E C O L O G I C A L R E V I E W

GIWW Bank Restoration of Critical Areas in Terrebonne
CWPPRA Priority Project List 10
State No. TE-43

September 9, 2004

This document reflects the project design as of the 95% Design Review meeting, incorporates all comments and recommendations received following the meeting, and is current as of September 9, 2004.

Figure 3. Typical Foreshore Rock Dike Section (USDA 2004).

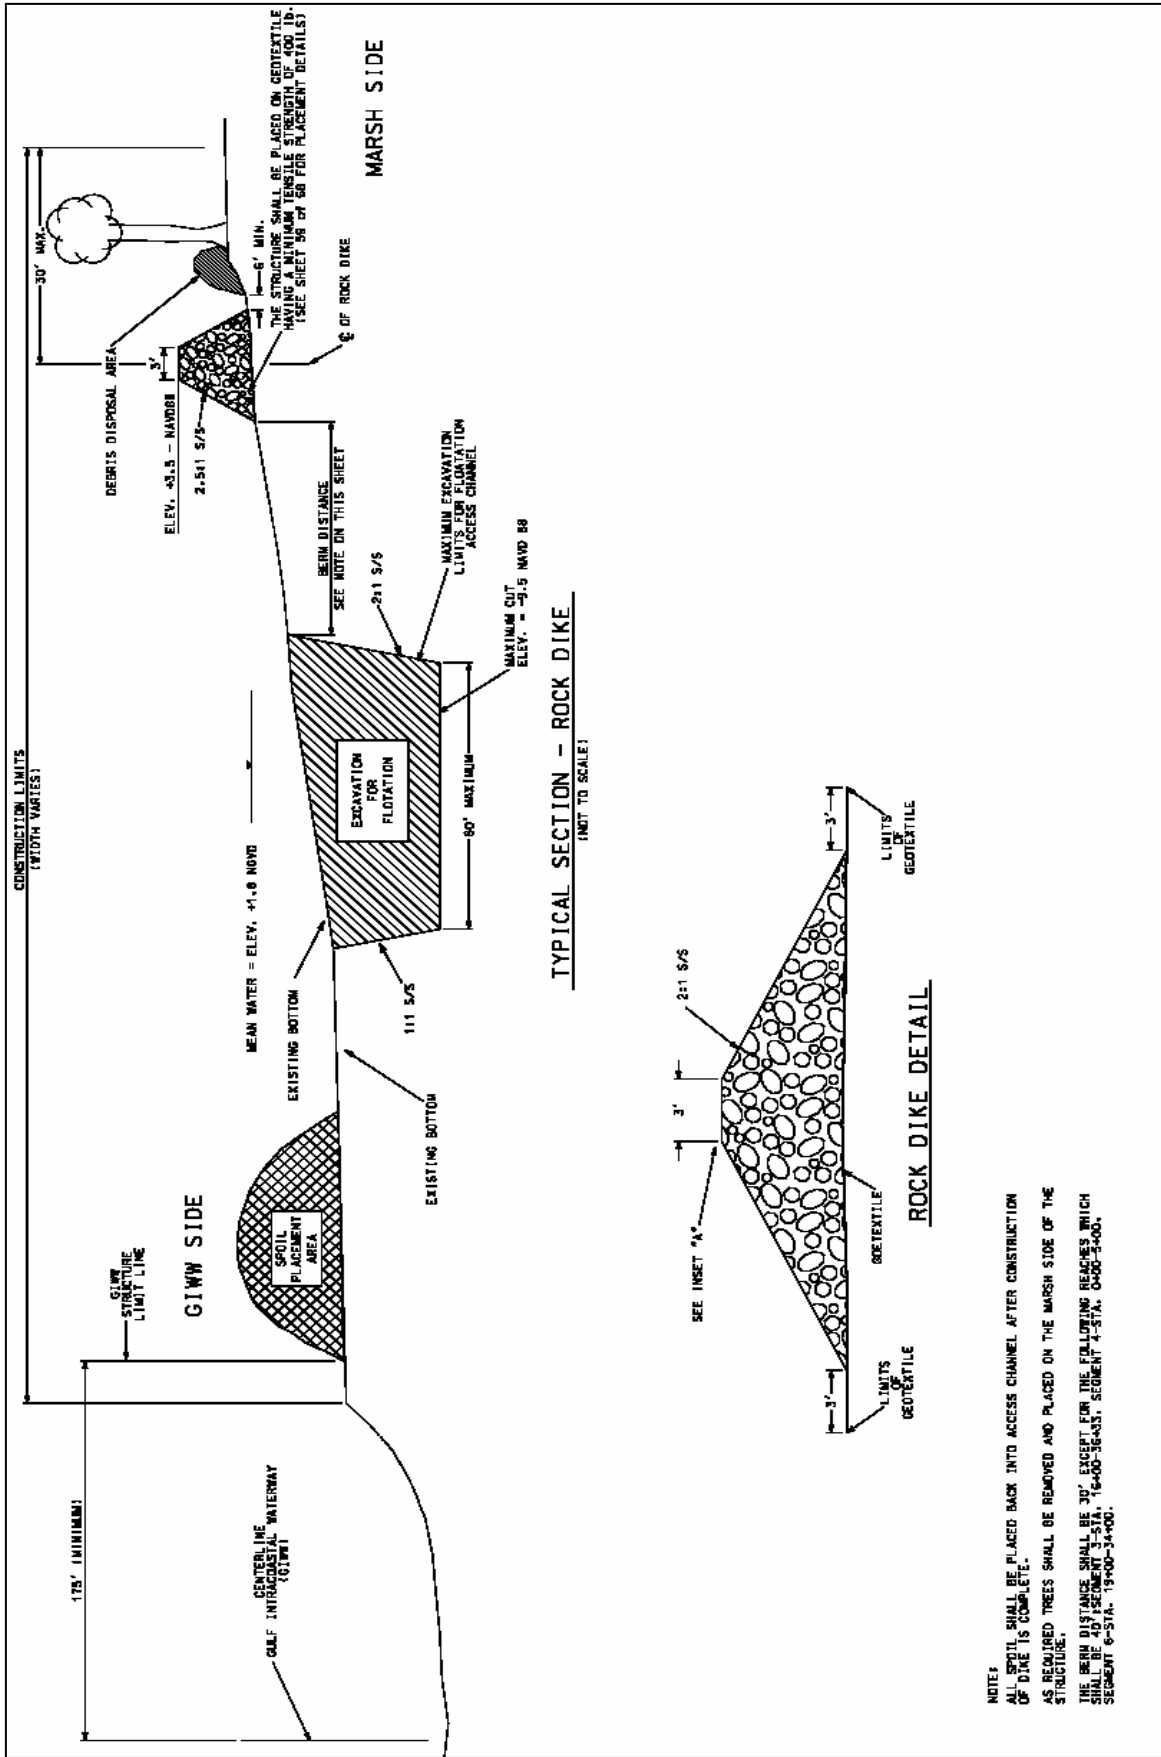
Following the initial 30% Design Review meeting in May 2003, it was determined by state and federal project engineers that the concrete sheetpile wall was not a viable option, due to high projected cost. A third option, using a combination of a foreshore rock dike (Figure 3) and a rock dike with a lightweight aggregate core (Figure 4), was proposed as a cost effective alternative to the concrete sheetpile wall. The overall height of the rock dike structures will be reduced in the new design compared to the engineering plans analyzed in the original geotechnical report. It is expected that by reducing the elevation of the rock dike from +4.0 feet NAVD-88 to +3.5 feet NAVD-88, and by moving the structure closer to shore at the -0.5 to -2.5 foot contour, less rock will be necessary to achieve an adequate height. As a result, overall pressure on the soil foundation will be reduced. In addition to reducing the height of the structure, it will be necessary to build the rock dike in three separate construction phases. Phase I will consist of constructing the rock dike to an initial elevation of +1.5 feet NAVD-88. Construction of phase II will start four months after phase I and includes adding additional rock material to the existing structure until an elevation of +3.5 feet NAVD-88 is achieved. Significant settlement is expected after construction of phase II, therefore, construction of phase III will begin one year after phase I and will call for the addition of rock material to top off the existing structure to achieve a final elevation of +3.5 feet NAVD-88. With the three phase construction plan, the rock dike and rock dike with lightweight aggregate core are expected to ultimately settle an average of 1.9 feet (Burns Cooley Dennis, Inc. 2003).

Despite the use of lighter structures at a lower crest elevation of +3.5 NAVD-88, some sections of the rock dike may ultimately settle to elevations that render it ineffective as a wave break. Water level data collected by the United States Geological Survey in the GIWW at Houma and in the GIWW at Bay Wallace (Station Numbers 07381331 and 073816505) indicate that the mean water level was 1.35 feet NAVD-88 (October 1999 to January 2004) and 1.73 feet NAVD-88, respectively (March 1998 to April 2004). Waves generated by boat traffic in the GIWW are estimated at 3.0 feet (USDA 2004). In response to the harsh environmental conditions in the GIWW, a detailed operations and maintenance plan has been prepared to ensure the structure remains at an effective design elevation of +3.5 NAVD-88 once construction is completed.

The geotechnical investigation prepared by Burns, Cooley, Dennis Inc. (2003) indicated that the structure will ultimately settle an average of 1.9 feet following construction completion. This analysis did not account for local rates of subsidence. Land within the *Coast 2050* Penchant Mapping Unit is subsiding at an estimated rate of 0.13-0.43 inches per year or 0.22-0.72 feet over the 20-year project life (Penland et al. 1989 and LCWCRTF&WCRA 1999). However, USDA and LDNR project engineers are confident that the high rates of subsidence within the project area will not reduce the effectiveness of the structure as a wave break. Additionally, during construction it is typical for the contractor to "overbuild" rock dike structures by as much as six inches to ensure adequate dike elevation. The anticipated "overbuilding" will help to negate the effect of the subsidence over the 20-year project life.

The soils in the GIWW Bank Restoration of Critical Areas in Terrebonne project area are extremely poor. As a result, the initial engineering design called for the construction of a concrete sheetpile structure, but high construction costs and design issues forced the project team to consider using a foreshore rock dike with and without a core of lightweight aggregate. The use of a lightweight aggregate core in the poorest soil reaches and construction of the rock dike in three phases may help maintain the elevation of the structure at or near +3.5 feet NAVD-88 in the short term. However, significant maintenance over the 20-year project life will be needed to avoid rendering the rock dike ineffective as a wave break.

Based on information gathered from similar restoration projects, engineering designs, and related literature, the proposed strategies in the GIWW Bank Restoration of Critical Areas in Terrebonne project will likely achieve the desired goals provided Operation and Maintenance funds are available for structure rehabilitation. It is recommended that this project progress towards construction authorization pending a favorable 95% Design Review.

Figure 4. Typical Lightweight Aggregate Core Foreshore Rock Dike Section (USDA 2004).

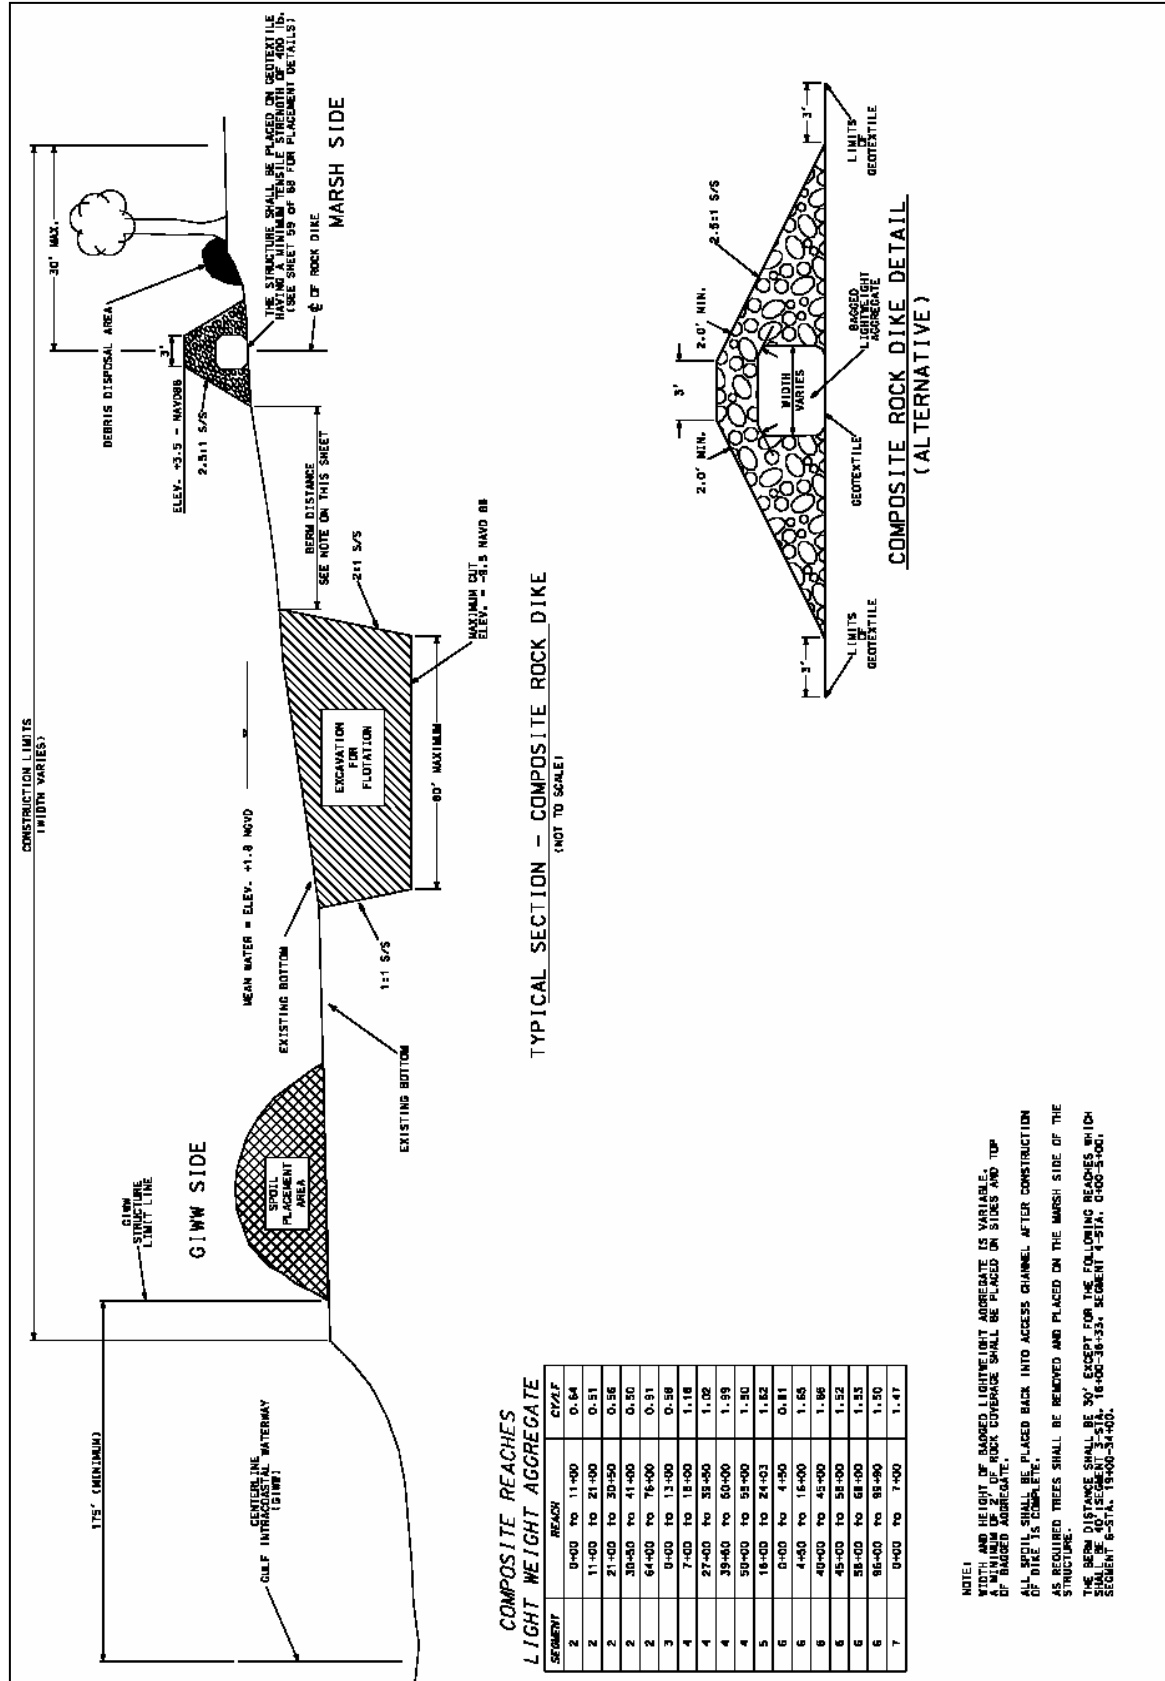
Due to high construction costs, the rock dike utilizing a lightweight aggregate core will be built only in areas where structure settlement is predicted to be particularly high. The rock dike with lightweight aggregate core will be used in soil foundations where the rip rap rock structure would need to be built at a slope greater than 1V:2.5H. In contrast to the rip rap rock dike, the lightweight aggregate core will be constructed entirely in one stage. The lightweight core material must be covered with rock in one step and as quickly as possible to avoid losses of the lightweight core due to wind and wave action.
